PROJECT: Summerlin West 1/2 - Kestrel Creek Avenue (Street 1)

CITY OF LAS VEGAS INTER-OFFICE MEMORANDUM

Drainage Study for:

Summerlin West V22 – Kestrel Creek Avenue (Street I)
(from Desert Foothills Drive to Kettle Ridge Drive <Street J>)

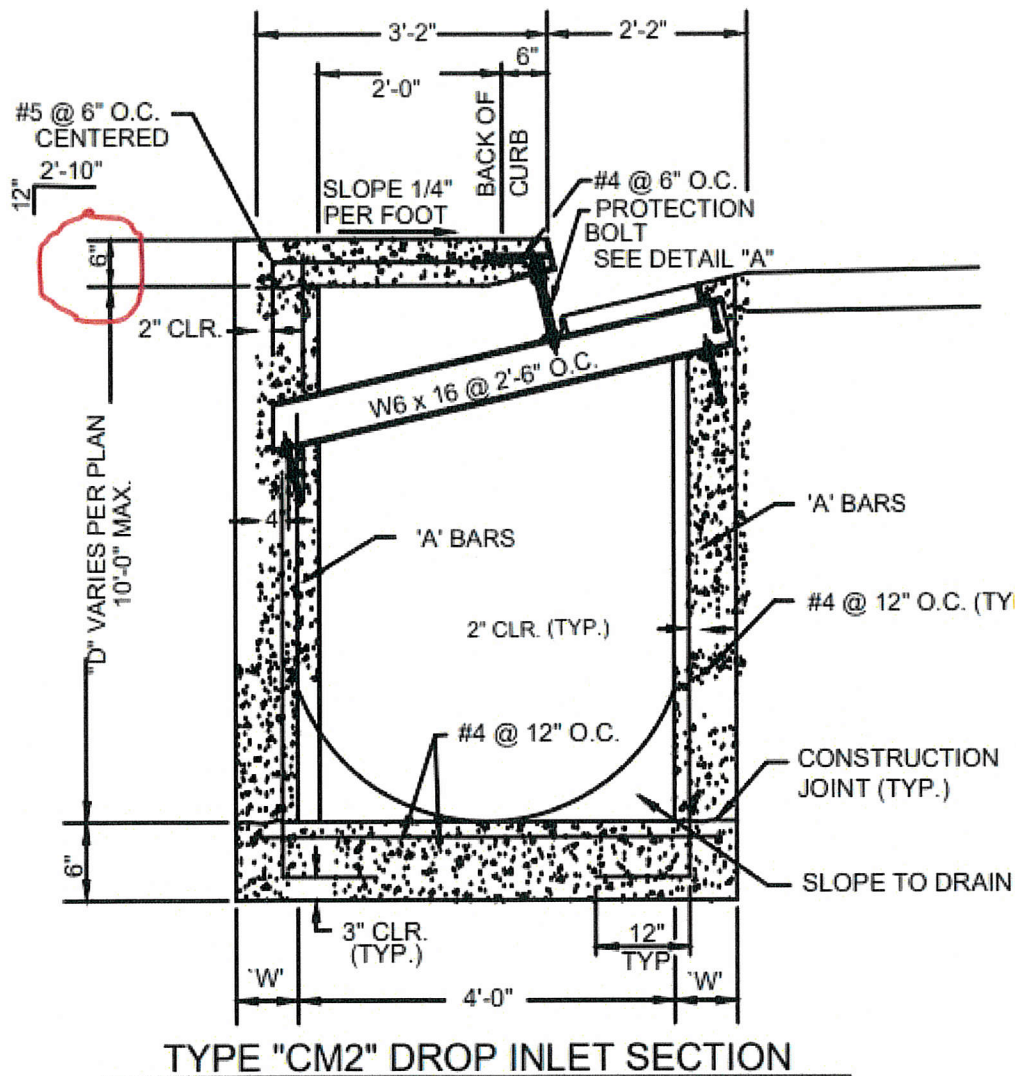
Please see screenshot below of standard drawing 412.1 showing confirmation of depth calculation methodology. Curb height is circled in red showing that it is not included in the calculation of "D".

CLV	00-00000	JOB NO. 100060654	DESIGNED BY: N. BARCOS
		DATE: OCTOBER, 2019	DRAWN BY: L. MAMACLAY
		DRAWING NO.	CHECKED BY: P. BATES
		9 /31	HORIZ.: 1"=20' VERT.: NONE

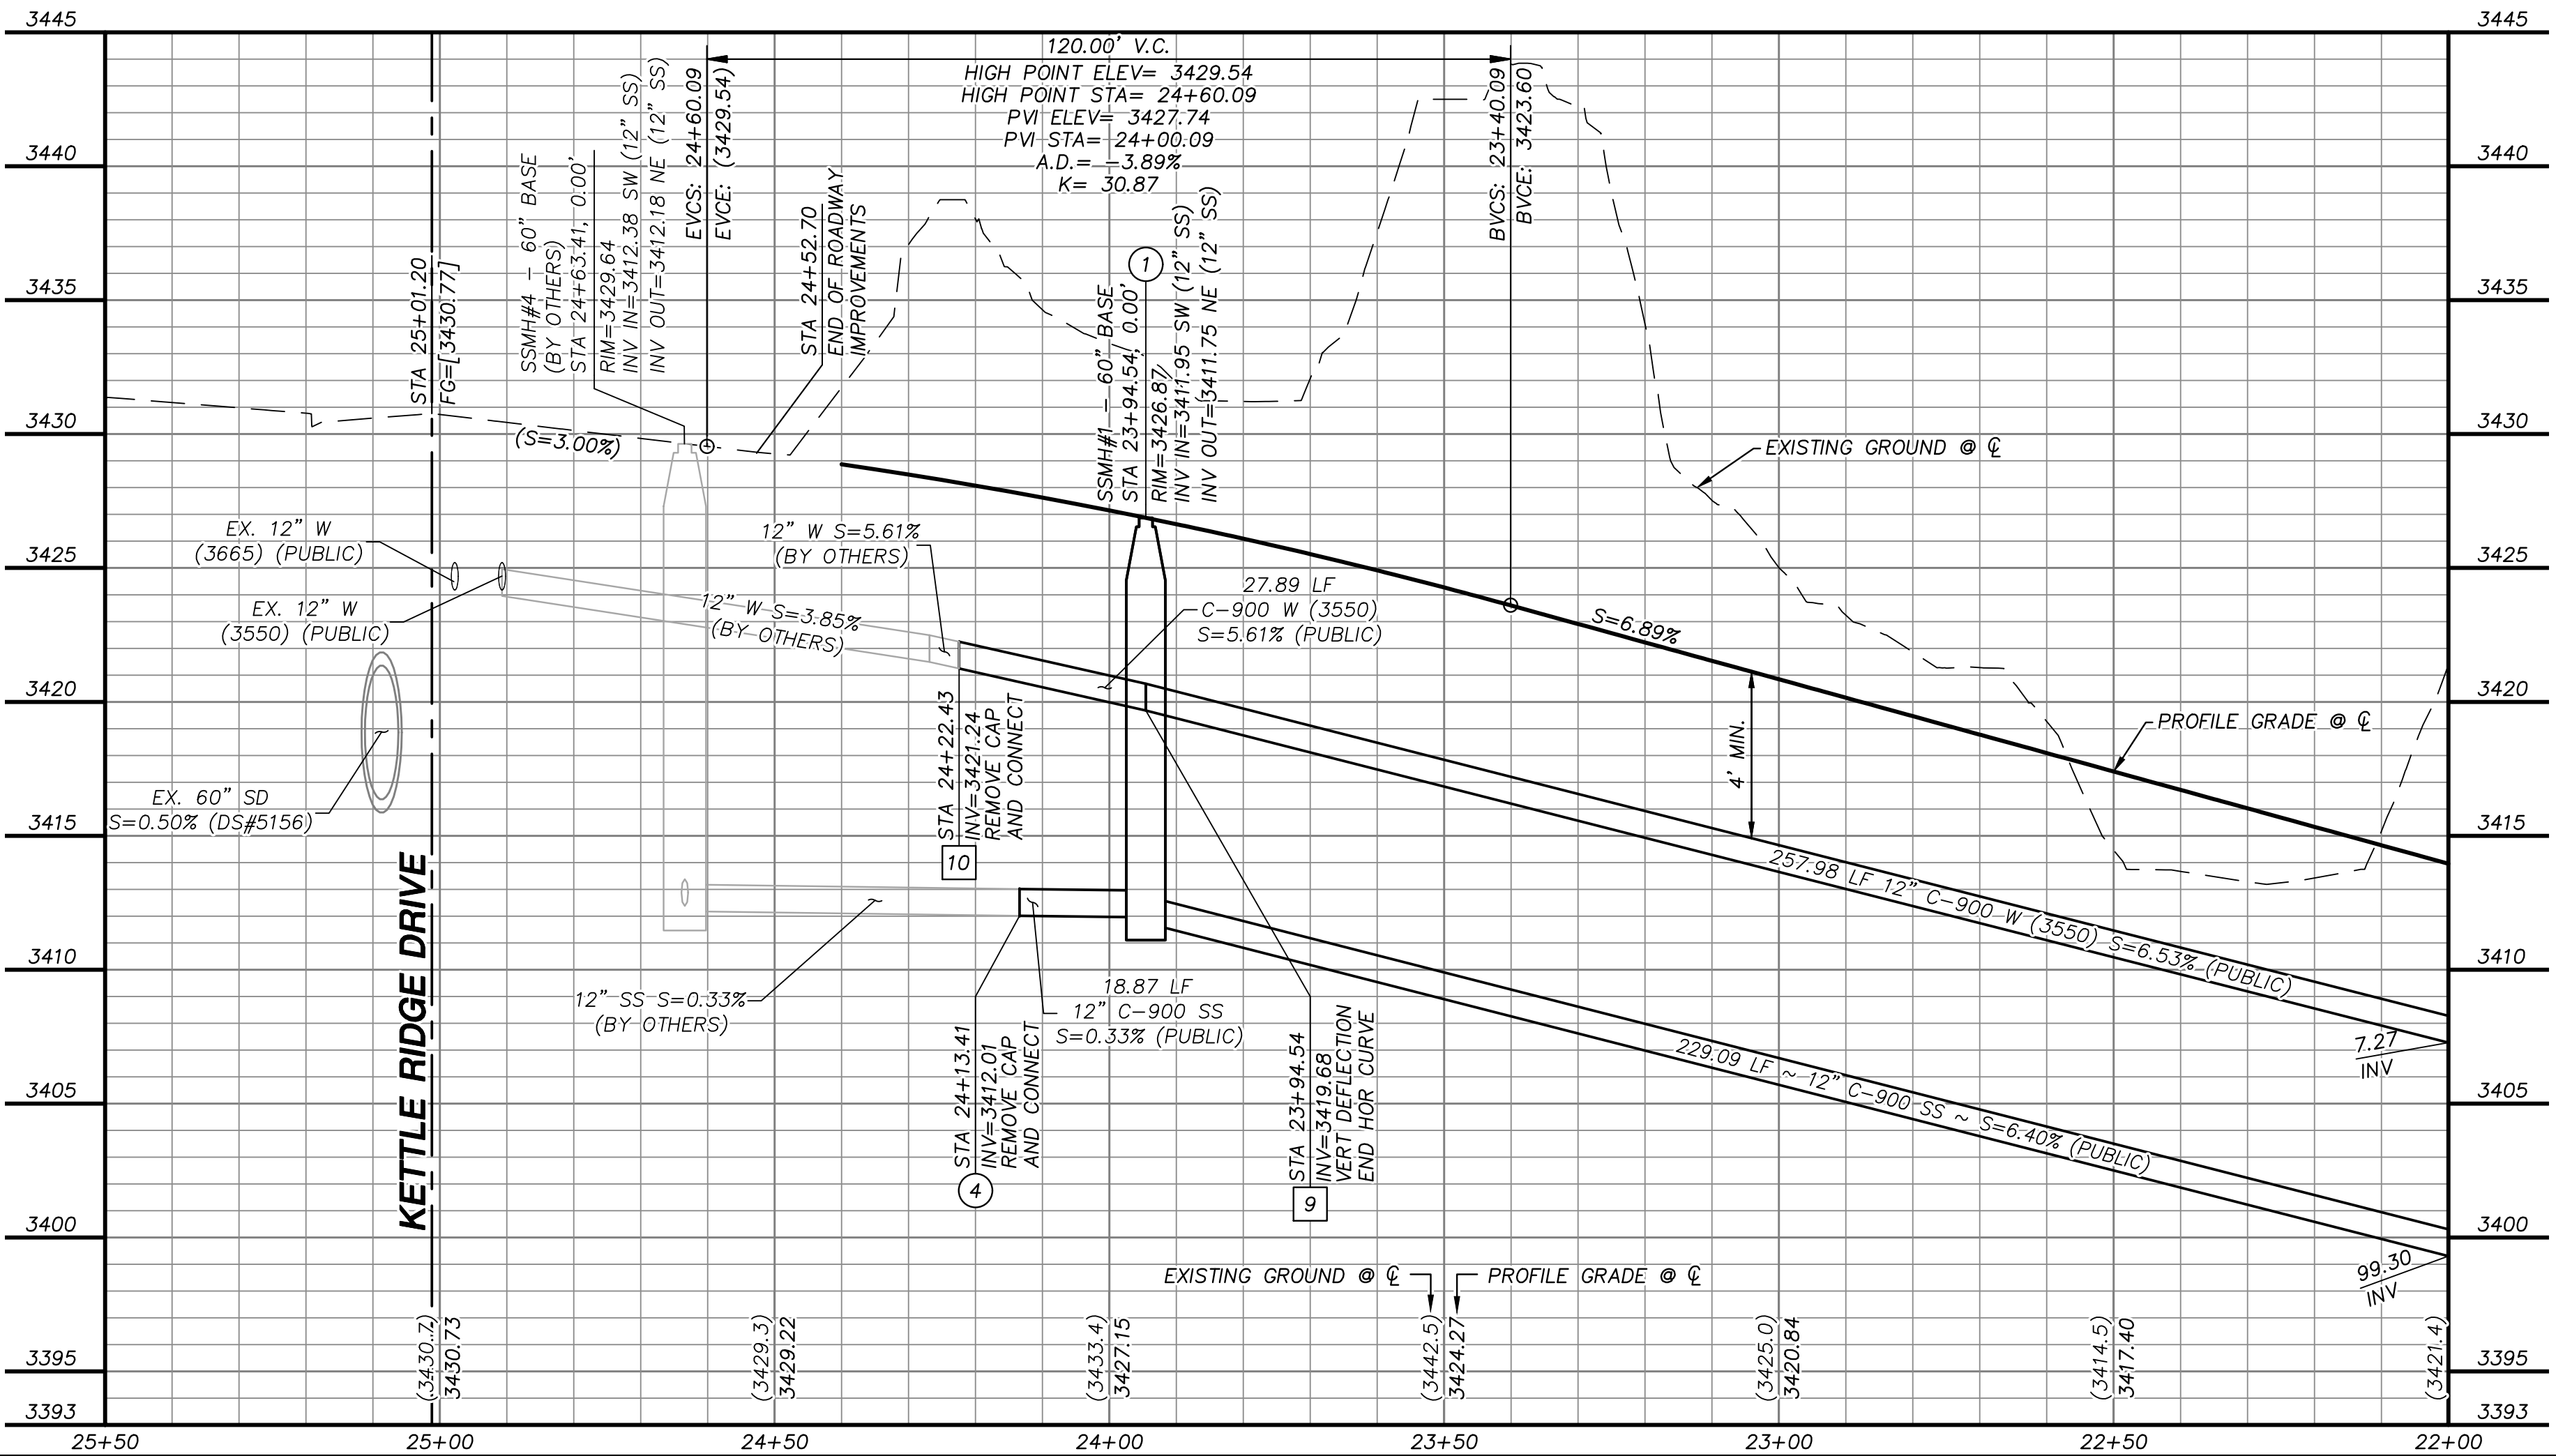
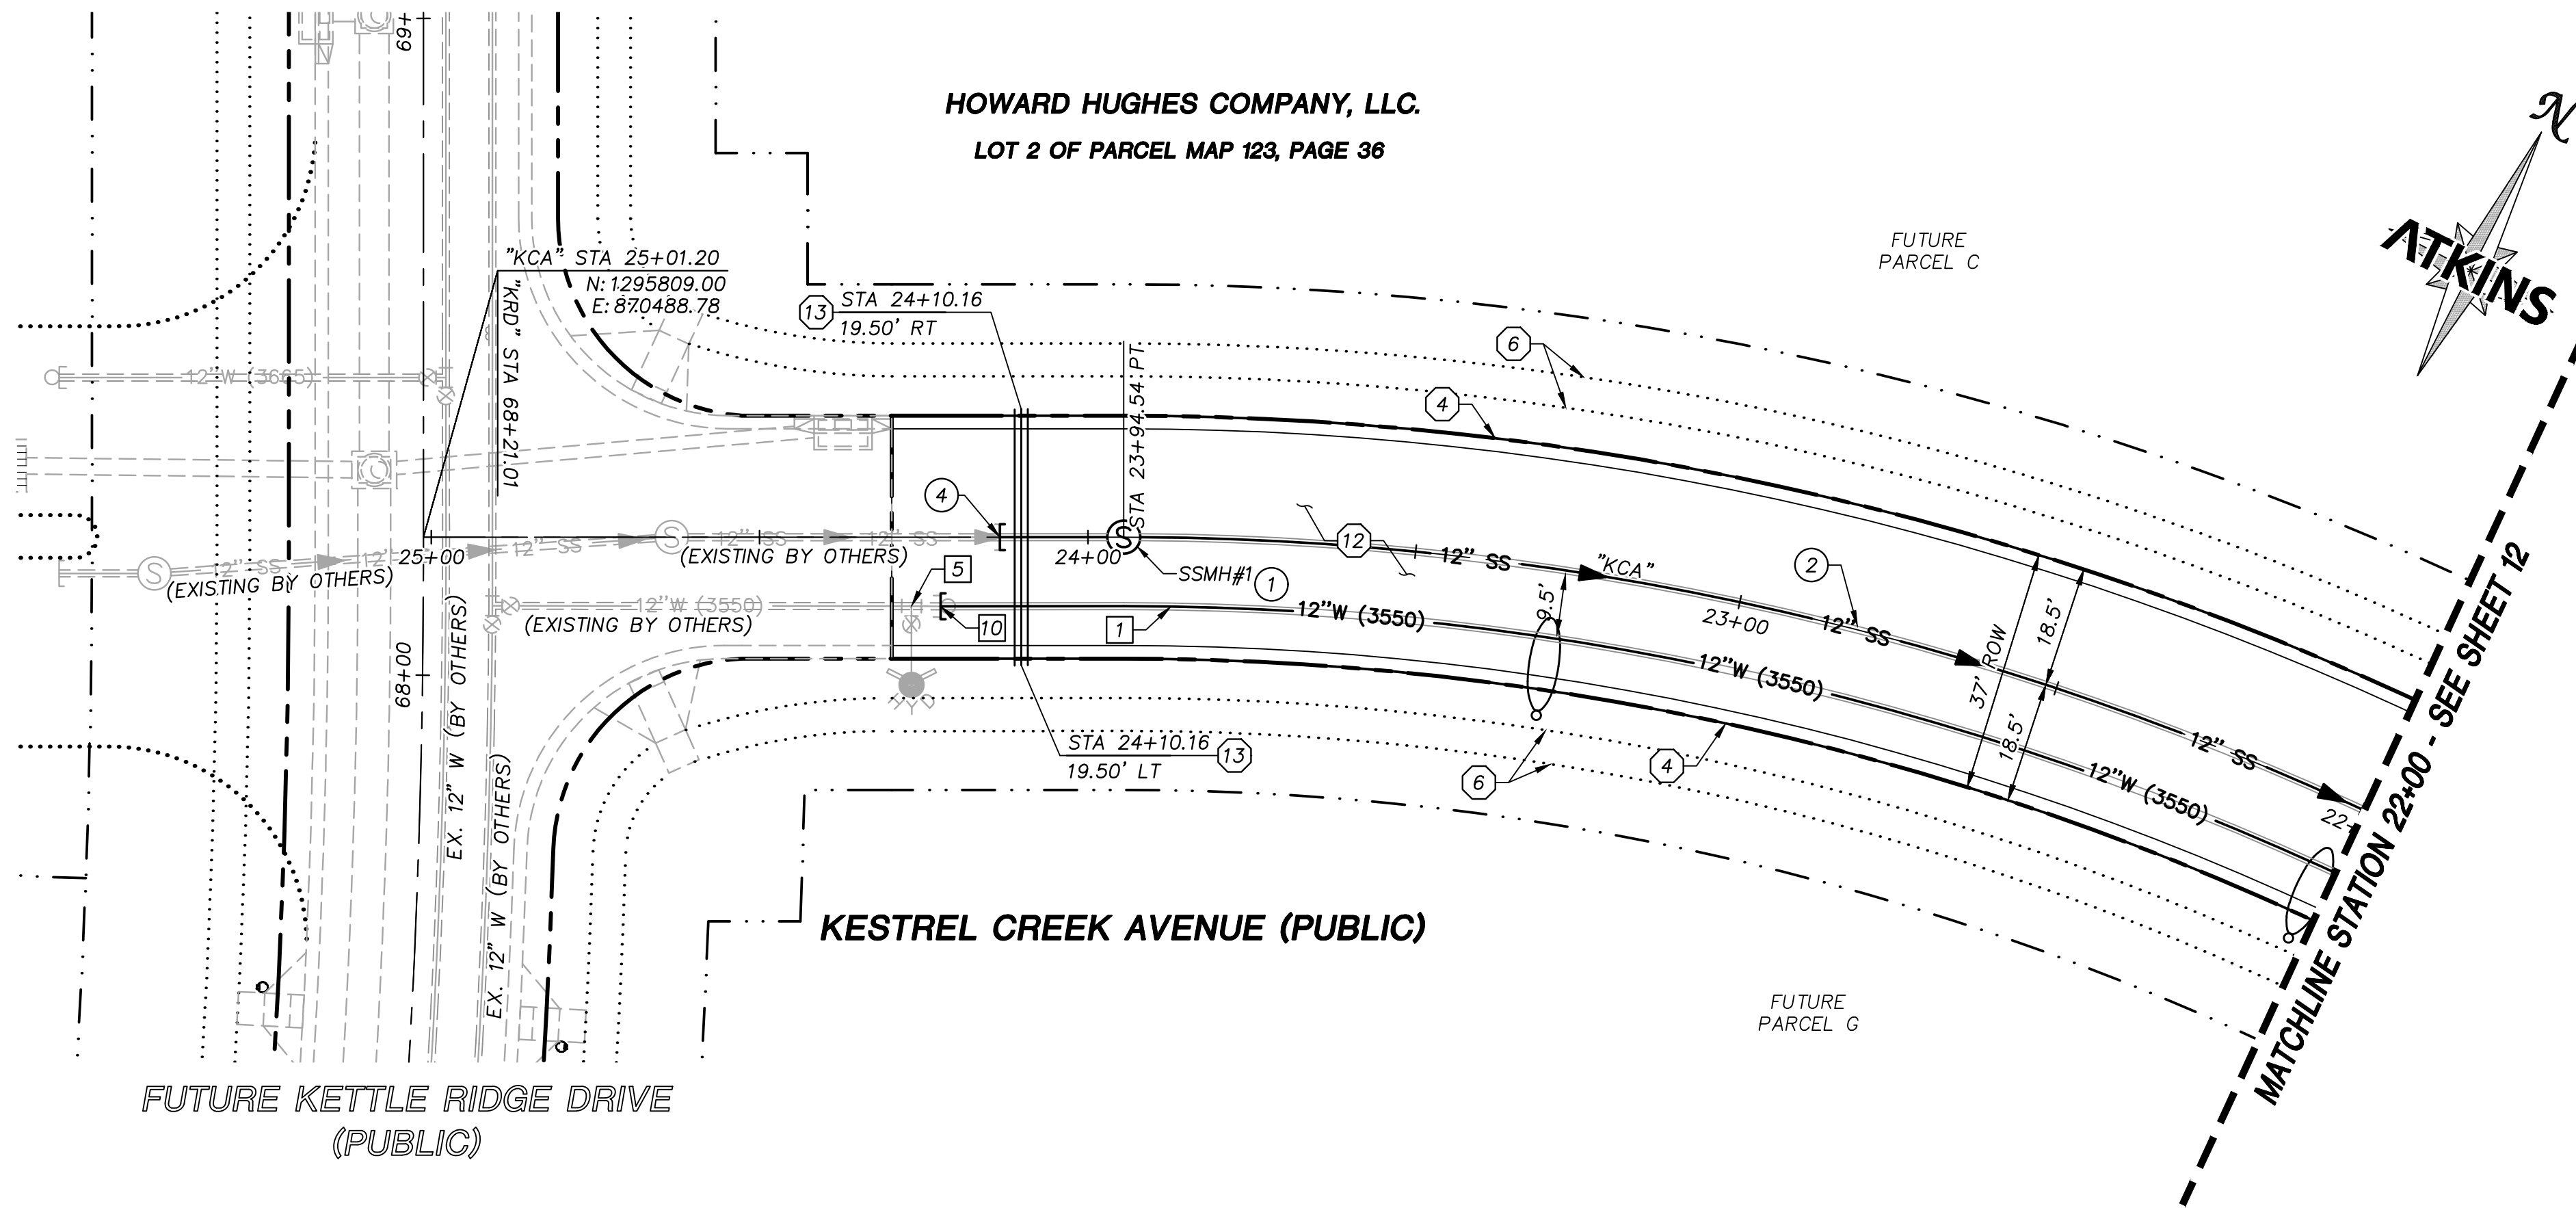
Comment #3: Sheet 9/27: A comment was issued for the *Kettle Ridge Drive Improvements Drainage Study* to relocate the regional storm drain towards the street center as much as possible. However, the subject improvement plan still shows that the regional facility under the curb & gutter of *Kettle Ridge*. Review and revise accordingly.

3. **Sheet 9/27:** A comment was issued for the *Kettle Ridge Drive Improvements Drainage Study* to relocate the regional storm drain towards the street center as much as possible. However, the subject improvement plan still shows that the regional facility under the curb & gutter of *Kettle Ridge*. Review and revise accordingly.

Comment response: The storm drain within the Kettle Ridge Drive Improvements Drainage Study has relocated the regional storm drain towards the center of the street as much as possible and has been revised accordingly in this study.
